PILGRIM NUCLEAR POWER STATION

AMENDMENT TO FACILITY OPERATING LICENSE

Amendment No. 140
License No. DPR-35

ATTACHMENT TO LICENSE AMENDMENT NO. 140

FIGURE 3.6.2
Pilgrim Reactor Pressure Vessel Pressure-Temperature
Limits for Subcritical Heatup and Cooledown

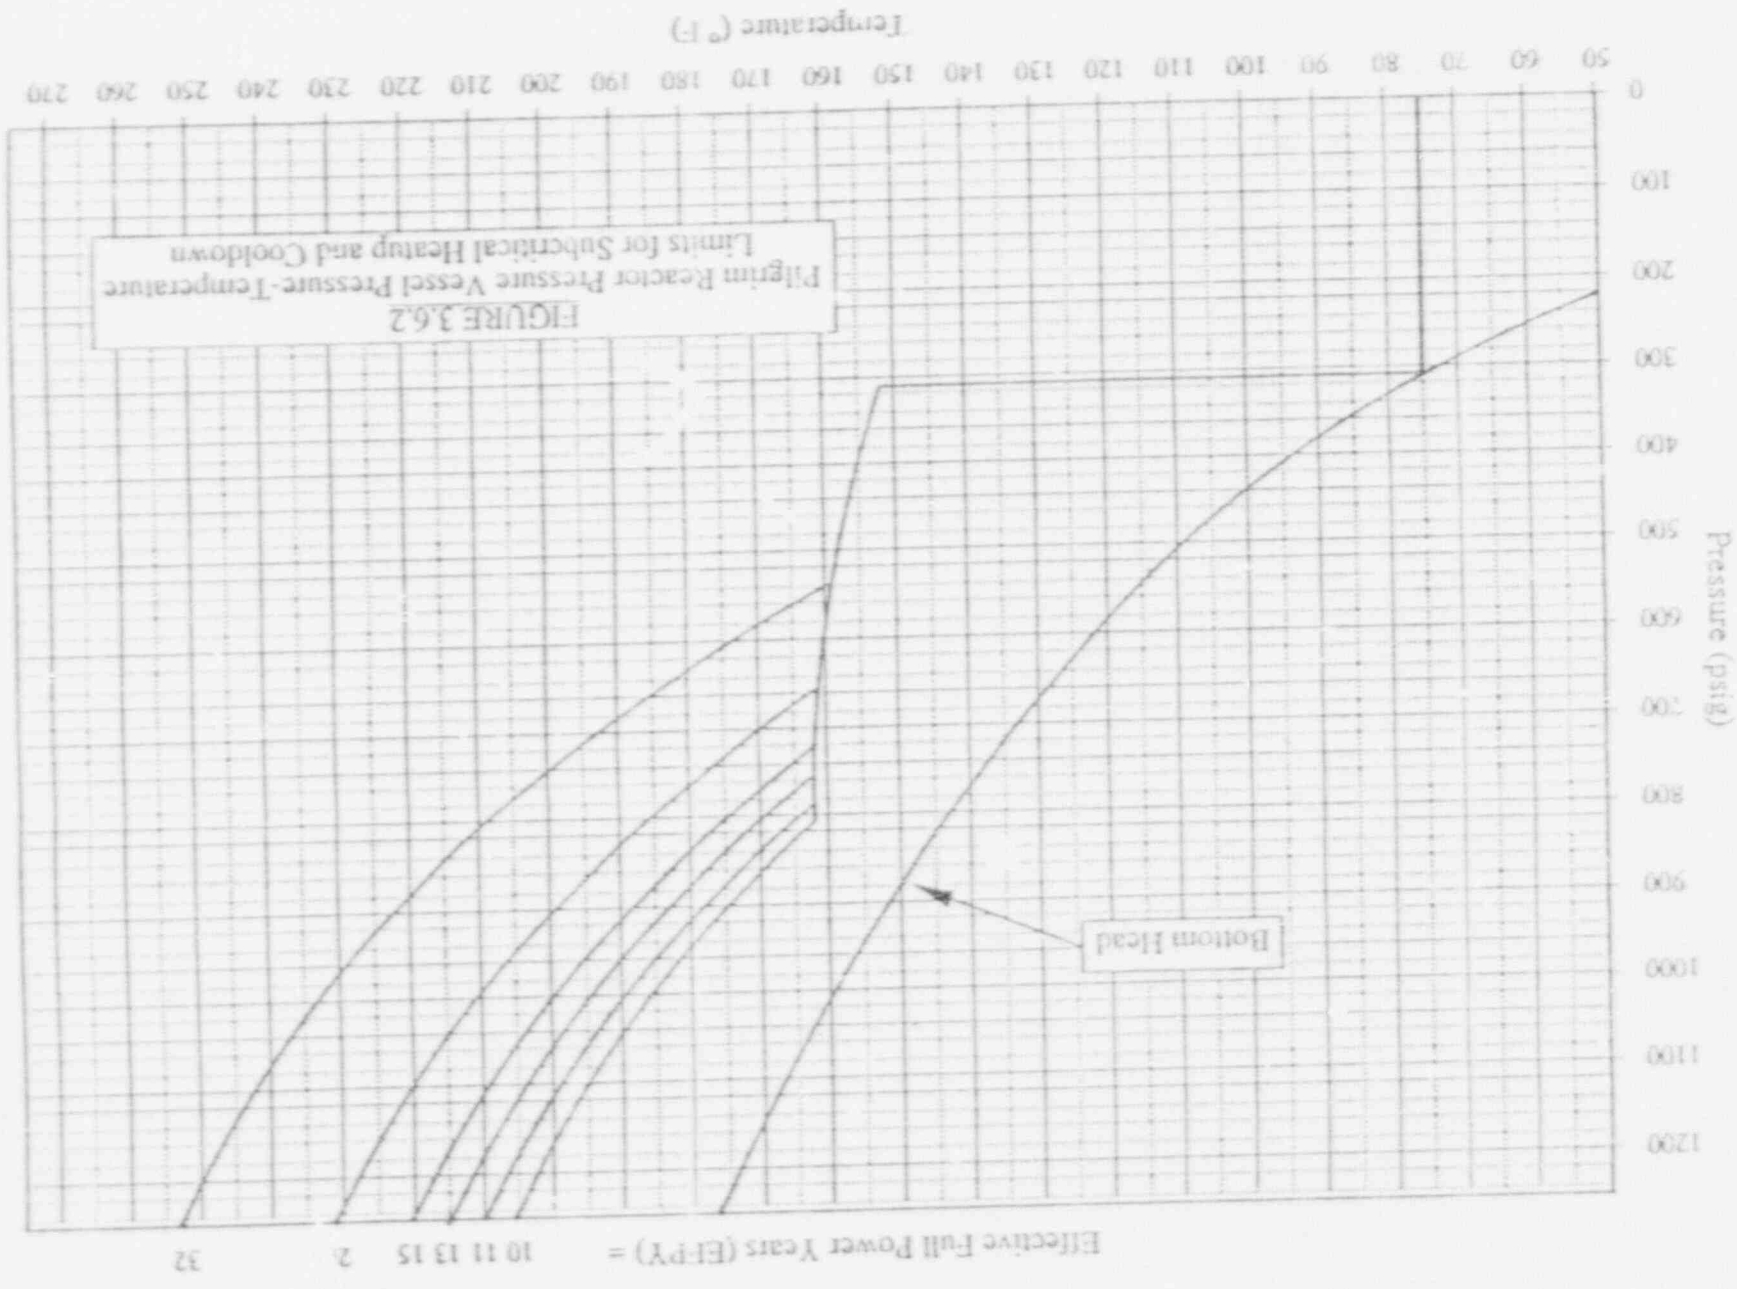
The bottom head, defined as the spherical portion of the reactor vessel located below the lower circumferential weld, was also evaluated. Reference transition temperatures (RT_{NDT}) were developed for the bottom head and the resulting pressure vs. temperature curves plotted on Figures 3.6.1 and 3.6.2. It has been determined that the bottom head temperatures are allowed to lag the vessel shell temperatures. Reference: Teledyne Engineering Services (TES) report TR-6051C-1, dated June 27, 1986. The referenced analysis utilizes the stress results established in the Combustion Engineering Inc., Pilgrim Reactor Vessel Design Report, No. CENC 1139, dated 1971, and combines the stress analysis results, specific to the bottom head, with the pressurization temperatures necessary to maintain fracture toughness requirements in accordance with the ASME Boiler and Pressure Vessel Code, Section III, the criteria of 10CFR Part 50, Appendix G, and the supplementary guidelines of Reg. Guide 1.99, Rev. 2.

For critical core operation when the water level is within the normal range for power operation and the pressure is less than 20% of the preservice system hydrostatic test pressure (313 psi), the minimum permissible temperature of the highly stressed regions of the closure flange is $RT_{NDT} + 60 = 55^{\circ}F$. A conservative cutoff limit of $75^{\circ}F$ was chosen as shown on Figure 3.6.3 and as permitted by 10CFR50 Appendix G, paragraph IV. A.3. This same cutoff is included in the limits for hydrostatic and leak tests and for non-critical operation, as shown on Figures 3.6.1 and 3.6.2 respectively, in order to be consistent with the limits for critical operation.
